# RENESAS TECHNICAL UPDATE

Product Category	MPU/MCU	Document No.	TN-SH7-A768A/E	Rev.	1.00
Title	Error correction about External Wait Timing Example of Bus state controller		Information Category	Technical Notification	
Applicable Product	SH7205 Group SH7265 Group	Lot No.	Reference Document	SH7205 Group Hardware Manual (REJ09B0372-0200) SH7265 Group Hardware Manual (REJ09B0351-0200)	
		ALL

Figure 10.7 External Wait Timing Example (Page Read Access to 16-Bit Channel)

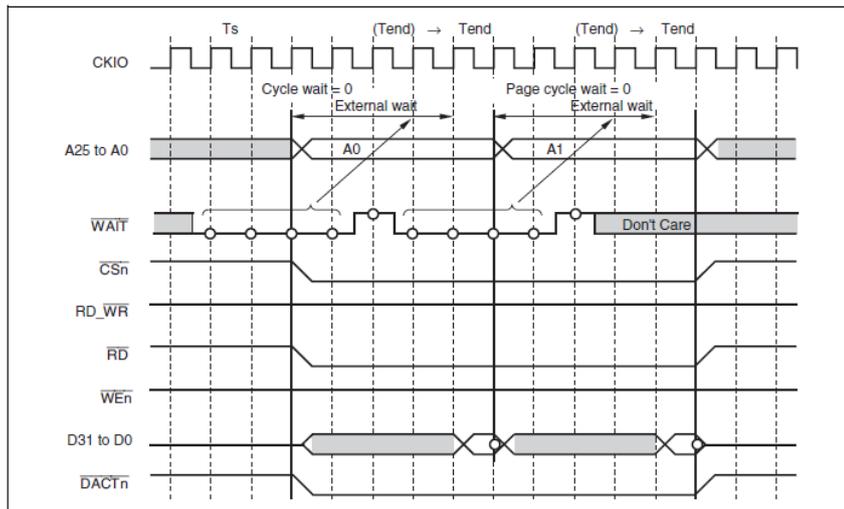
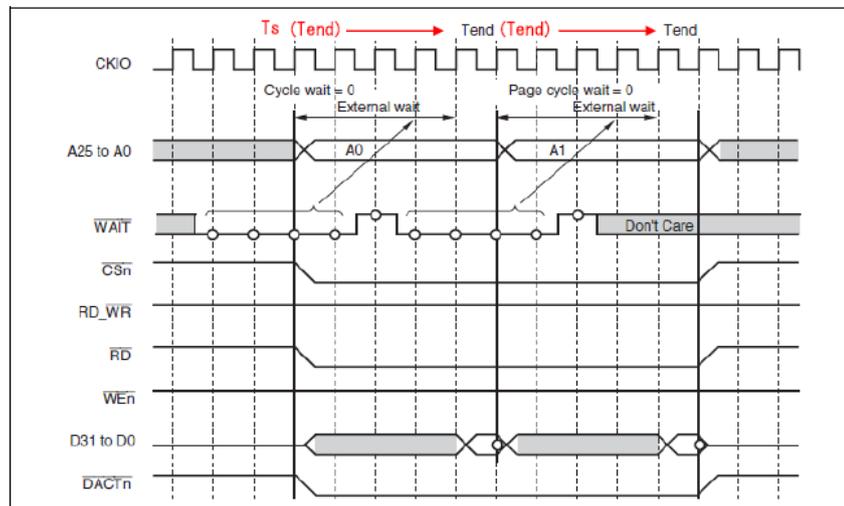
We would like to inform you of the following error correction about Bus state controller (BSC) in the above-mentioned applicable products.

[Error]

[Correction]
